June 11, 2025

**ADDENDUM #3
BID NUMBER: 24-11**

ESPLANADE BUILDING 4 ELEVATOR ADDITION

SINGLE-LINE DIAGRAM - BUILDING 4
NOT TO SCALE

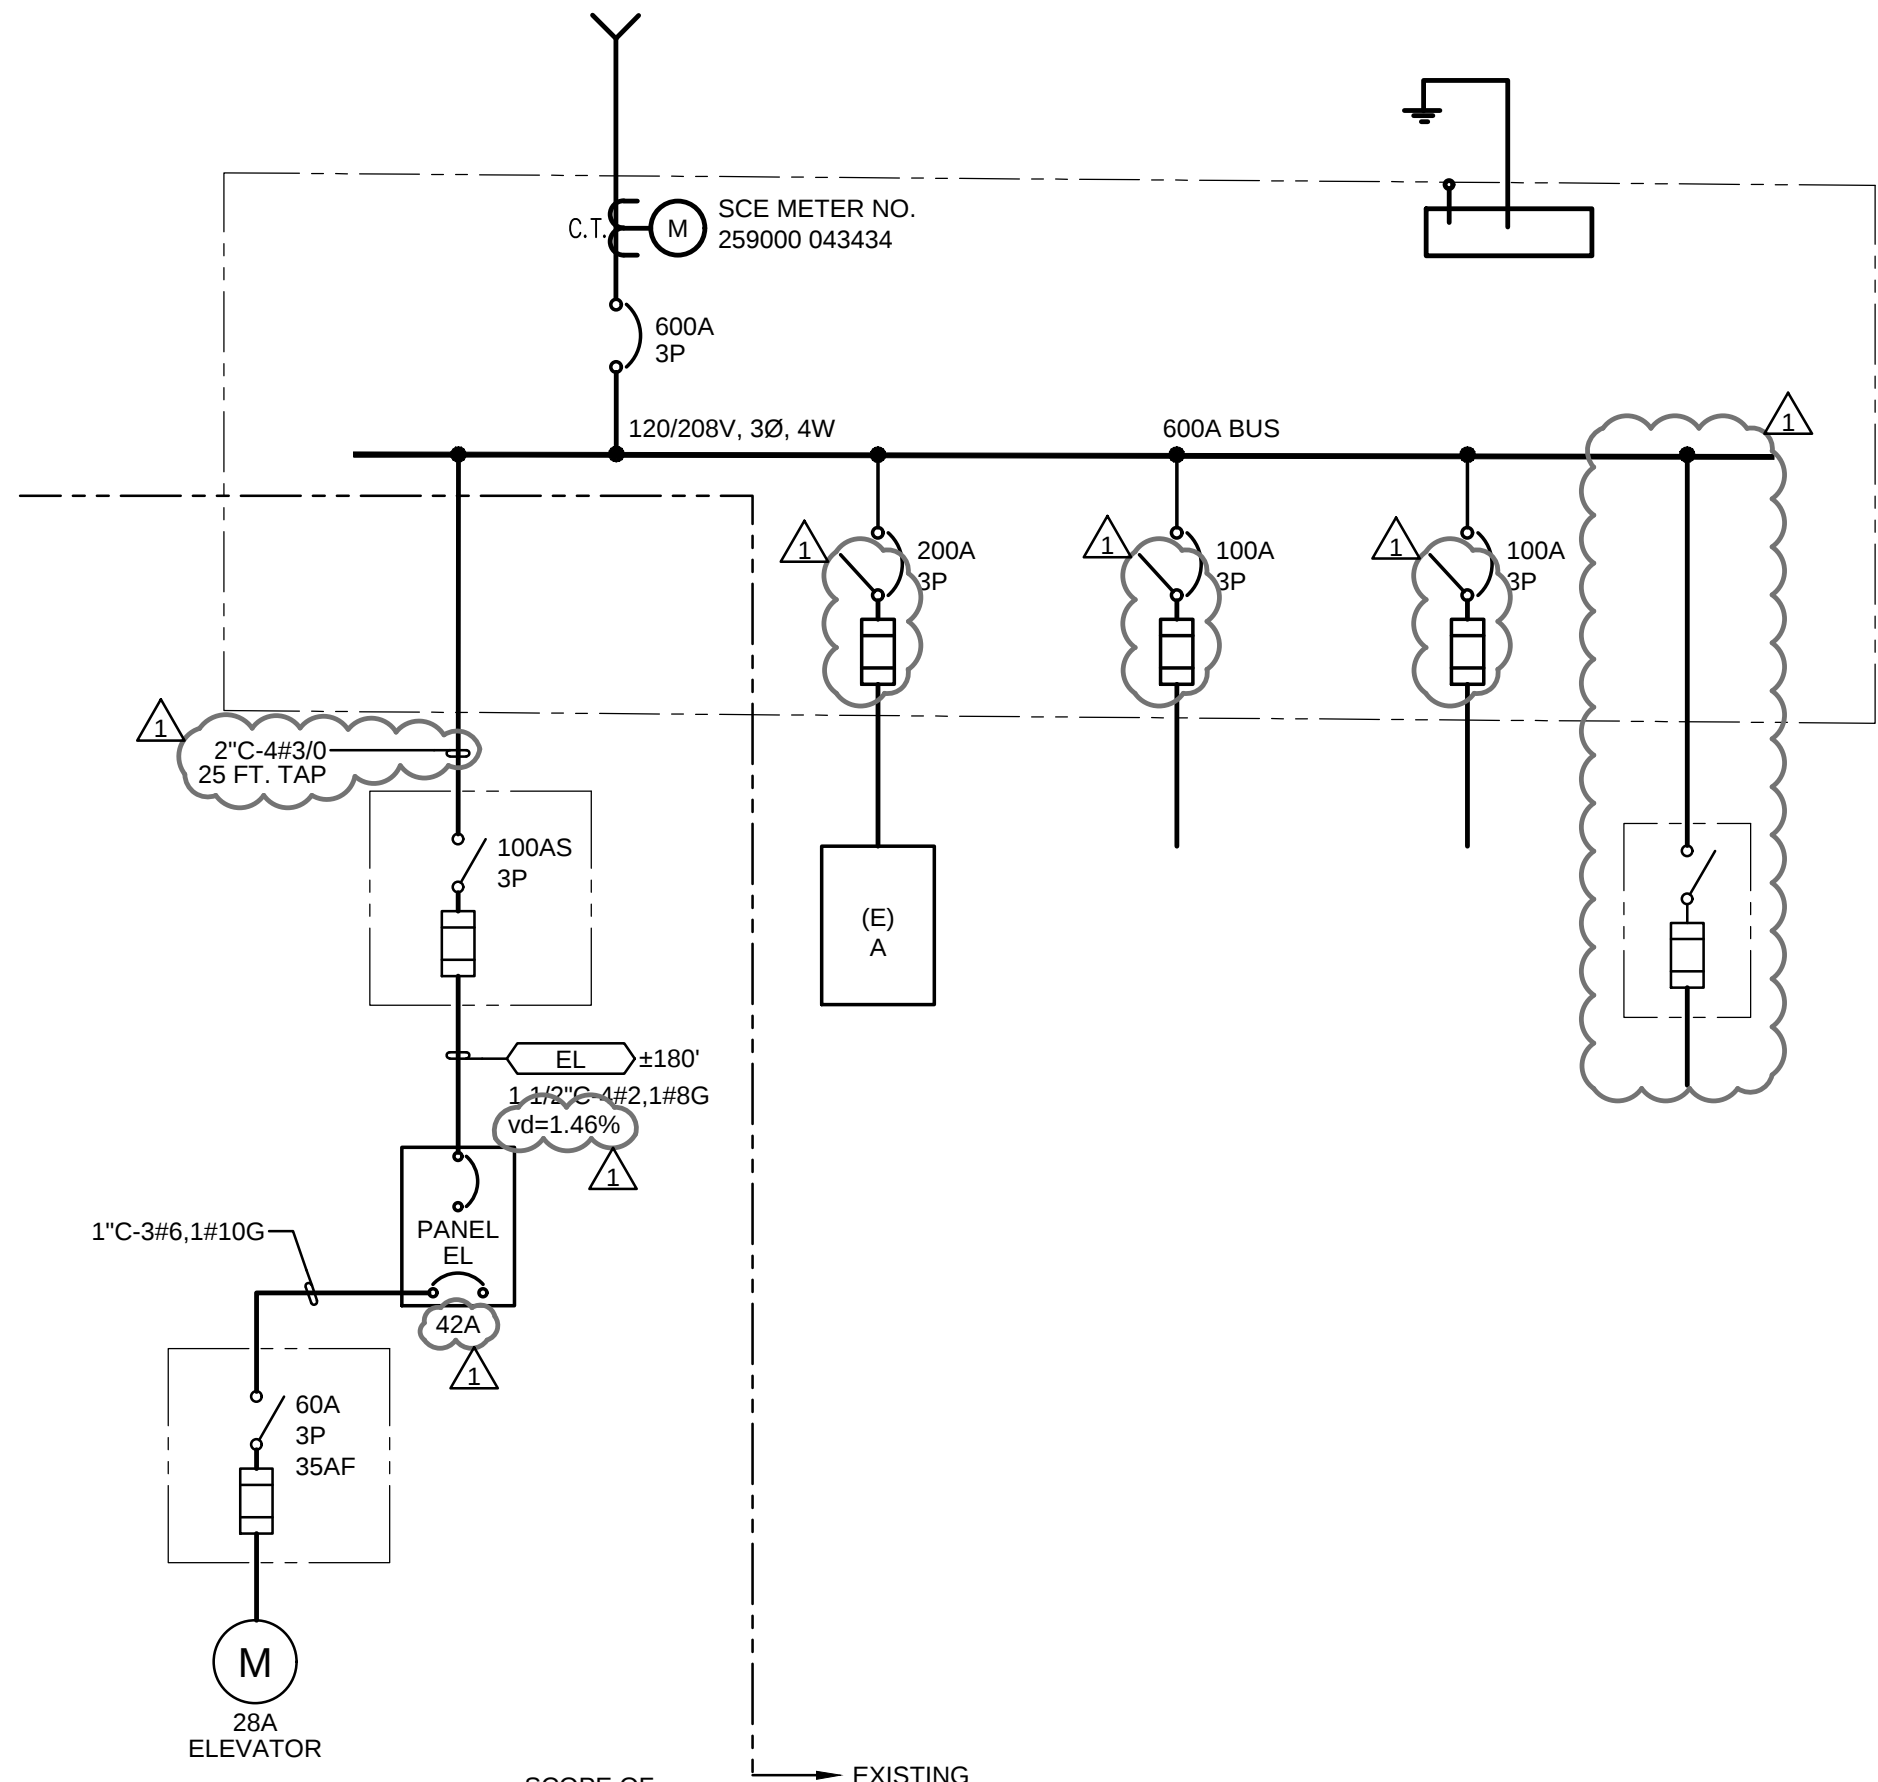
- a. Detail 2 – Reroute panel "EL" Feeder to roof. Revise Plan Note #1 to match change.
- b. Detail 3 – Revise Feeder tap to utilize the 25ft. tap rule. Update Single Line Diagram to match field condition.
- c. Detail 4 – Revise 2-way communication block diagram to provide connection to monitoring company.
- d. Refer to attached Sheet E001 for clouded revisions noted above.

ENLARGED ROOF FRAMING PLAN

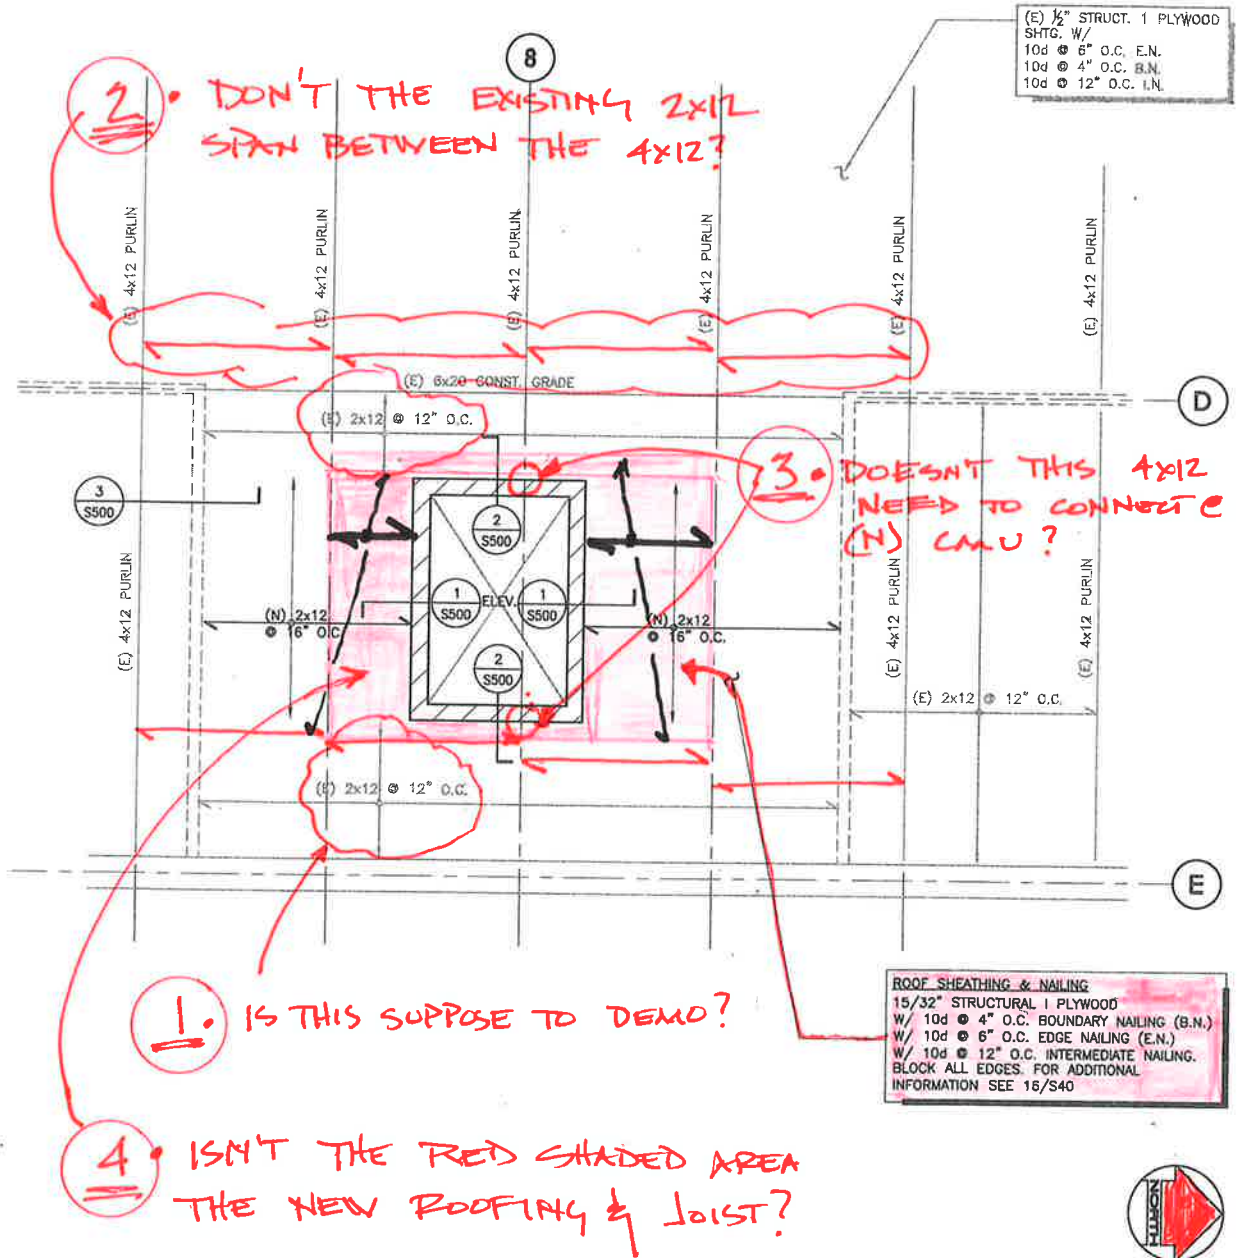
2. Question: Detail 3/S102 shows the 2x12 joist on the east and west side of the new elevator shaft to remain. How can the 2x12 Purlin on grid line 8 stop at the 6x20 on grid D if joist remain?

ADDENDUM #2 / QUESTION #3
CLARIFICATIONS.

- Response: Keep (E) 2x12 framing in place as shown on plans.
3. Question: The existing 2x12 span between the 4x12 Purlins'. The plans shows the 2x12 spanning north to south which is correct, only they are between purlins not over purlins. The joist do not span east to west.
